## **Supplementary Statement**

- 1.1 The applicant seeks planning permission from the Town Planning Board (the Board) to use *Lots 1161 S.B RP (Part) and 1162 (Part) in D.D. 82, Ta Kwu Ling, New Territories* (the Site) for **‘Temporary Open Storage of Construction Material and Machinery with Ancillary Facilities and Associated Filling of Land for a Period of 3 Years’** (the development) (**Plan 1**).
- 1.2 In view of the pressing demand for outdoor storage space in New Territories in recent years, the applicant would like to continue to use the Site for storage of construction material (i.e. scaffold, bricks, tiles, column, screws etc.) and machinery (i.e. tamping rammer, generator, elevated platform etc.) to support the local warehousing and storage industry.

**Proposed Temporary Open Storage of Construction Materials  
and Machinery with Ancillary Facilities for a Period of 3 Years  
and Associated Filling of Land in "Agriculture" Zone, Lots 1151,  
1152, 1161 S.B RP (Part) and 1162 (Part) in D.D. 82, Ta Kwu Ling  
(Compliance with Approval Condition (a) for Planning Application No. A/NE-TKL/763)**

Appendix I - Response-to-Comment

DRAWING NUMBER  
**FIGURE 3**

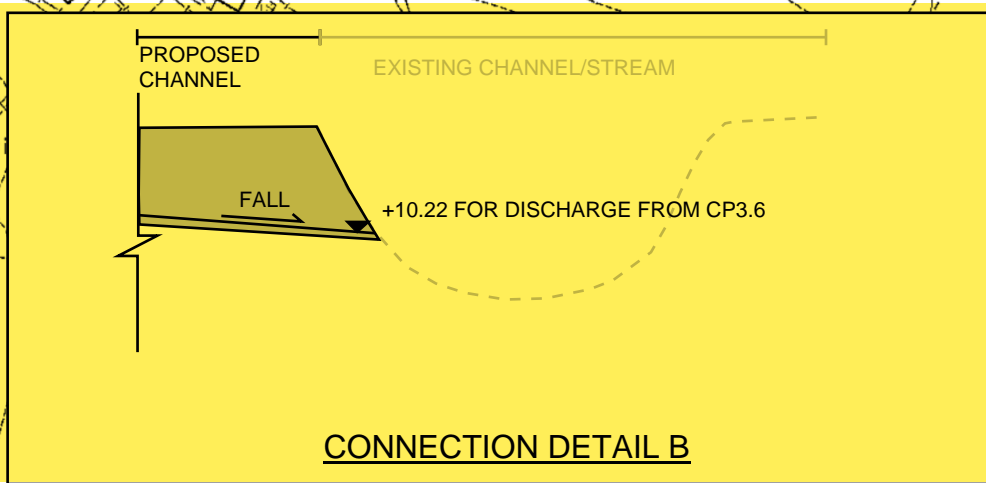
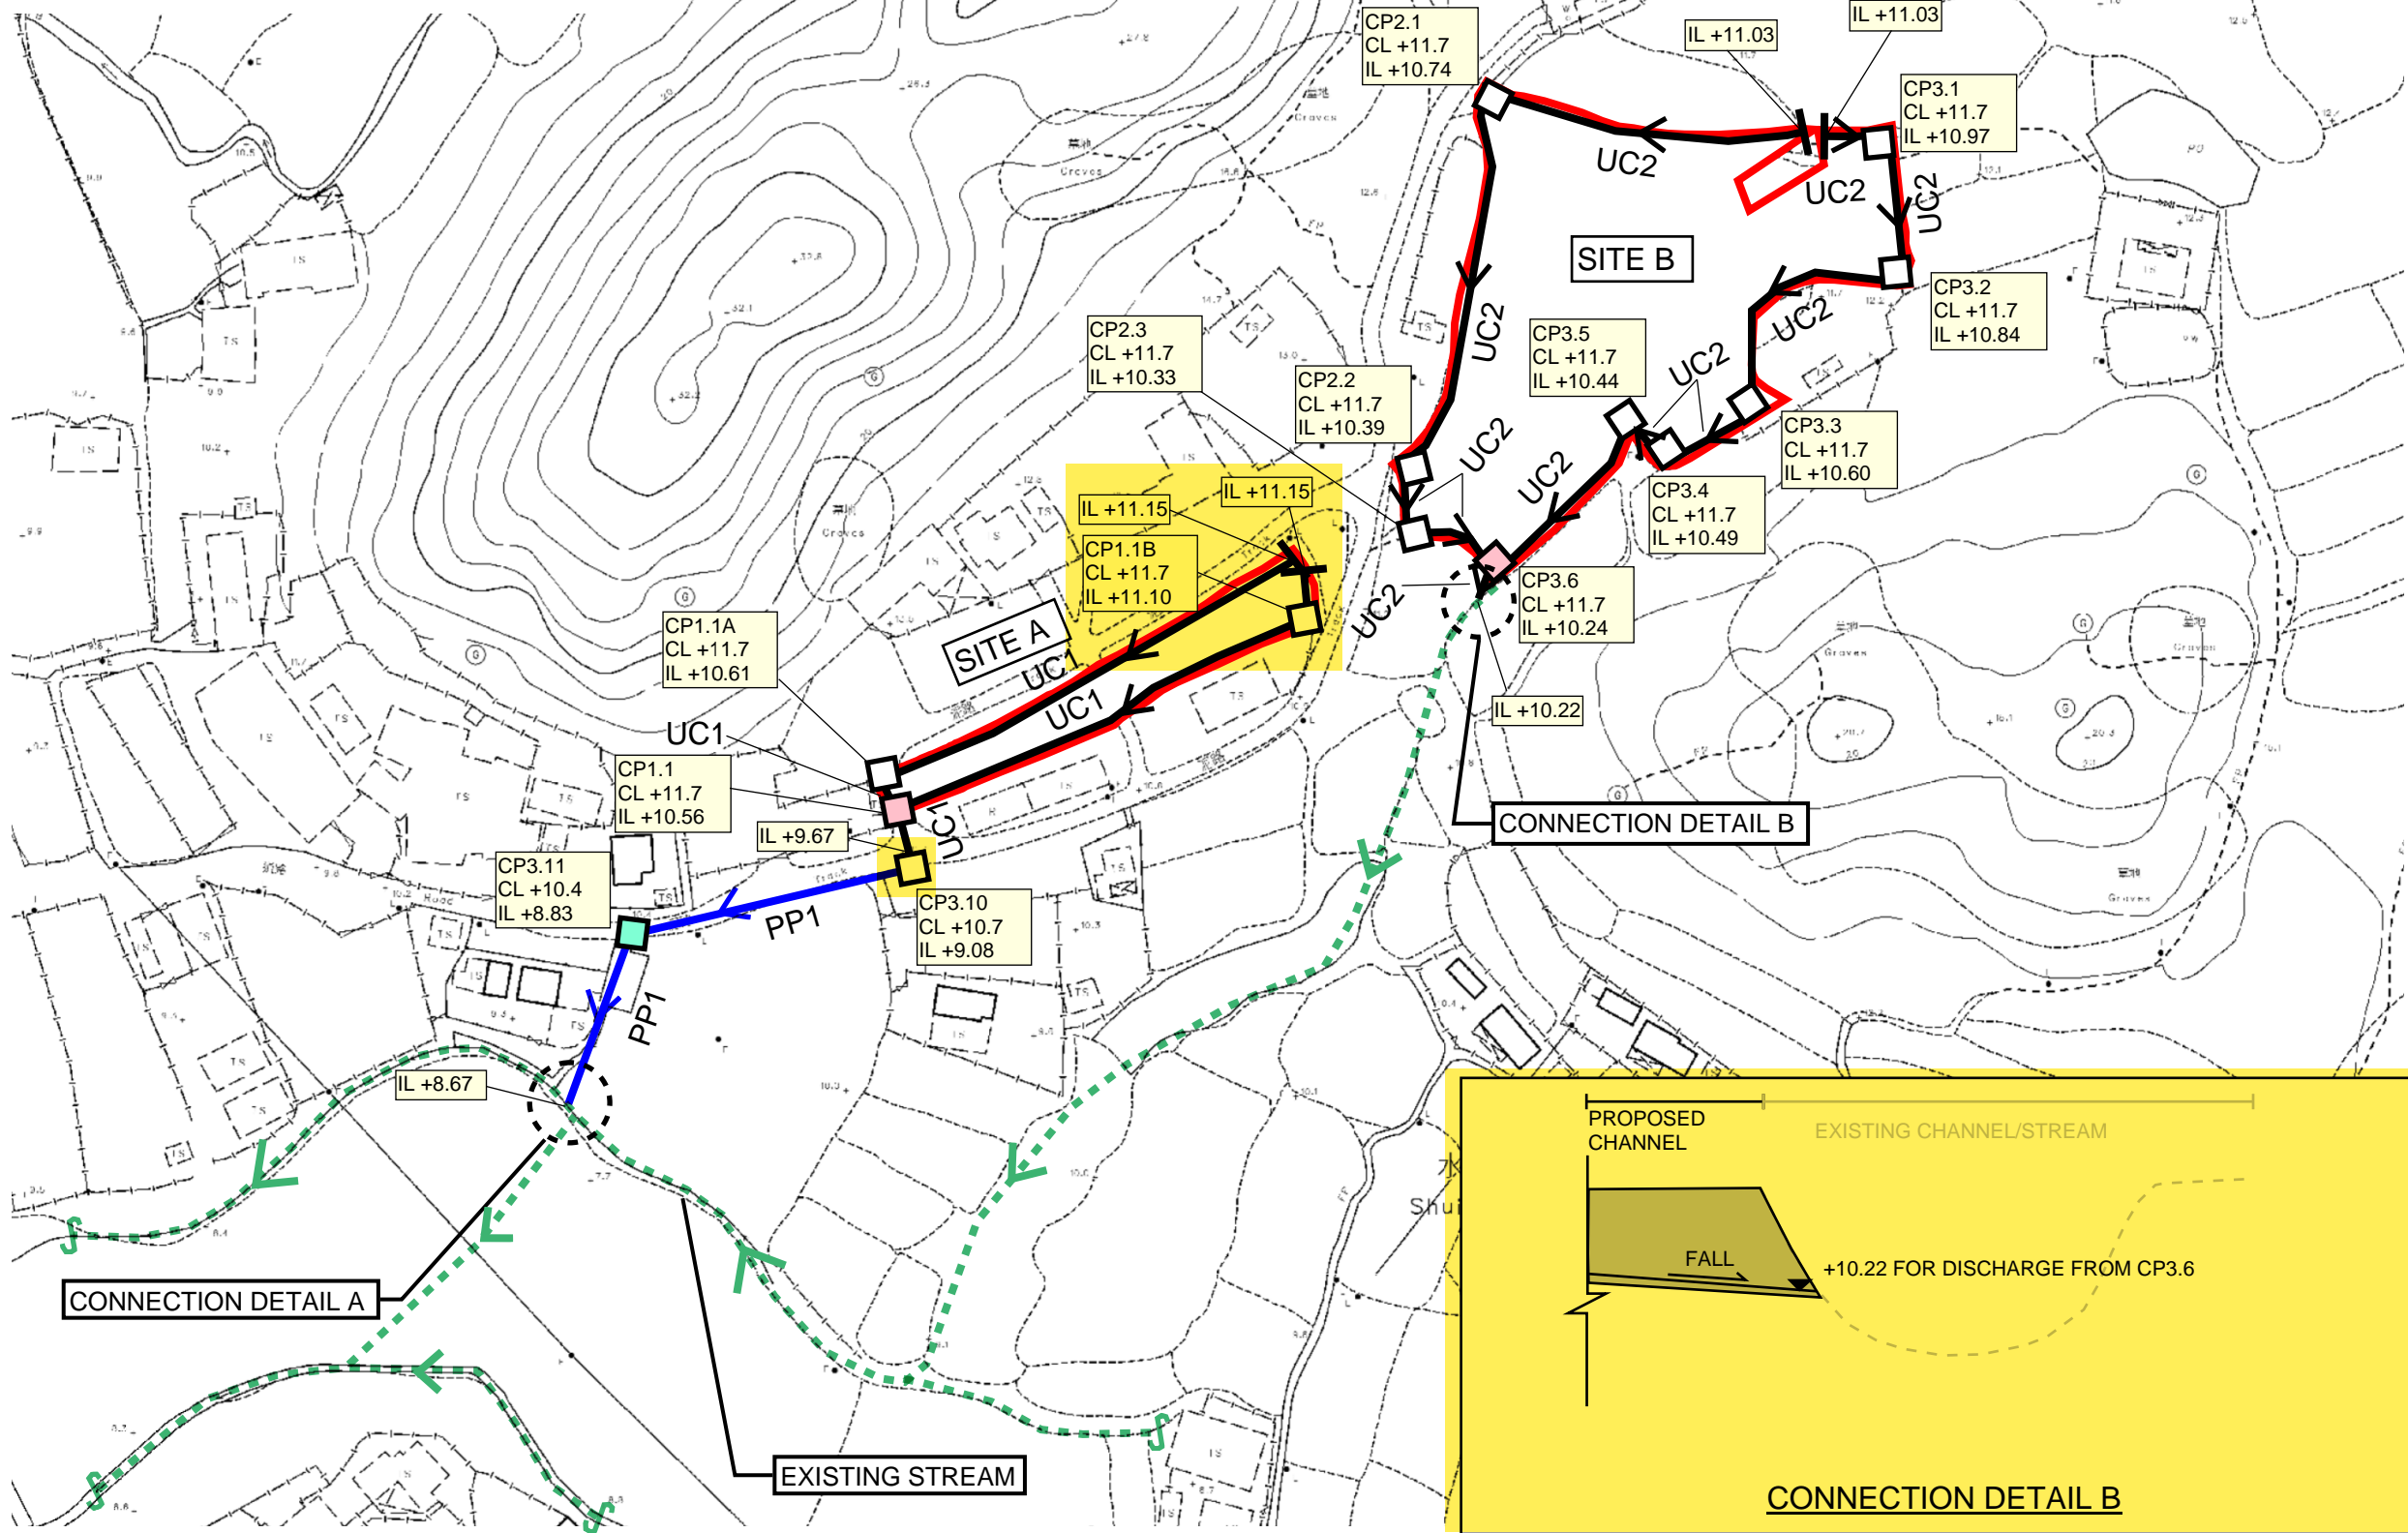
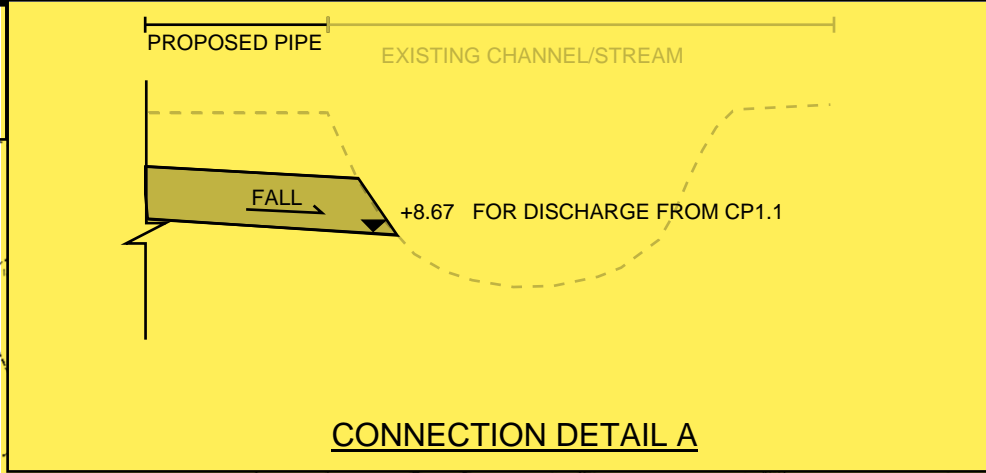
2	<p>Figure 3 refers;                      (a) connection detail A is not applicable to the connection between UC2 (downstream of CP3.6) and the existing stream. The applicant should review;                      (b) CP3.10 should be a catchpit instead of a manhole; and</p>	<p>Noted. Please refer to updated Figure 3.                      a) Detail B added for your review.                      b) CP3.10 is revised to catchpit for your review.</p>
3	<p>The applicant should consider to provide u-channel along the north-east boundary of</p>	<p>Noted. Please refer to updated Figure 3. U channel is provided at north-east boundary of</p>
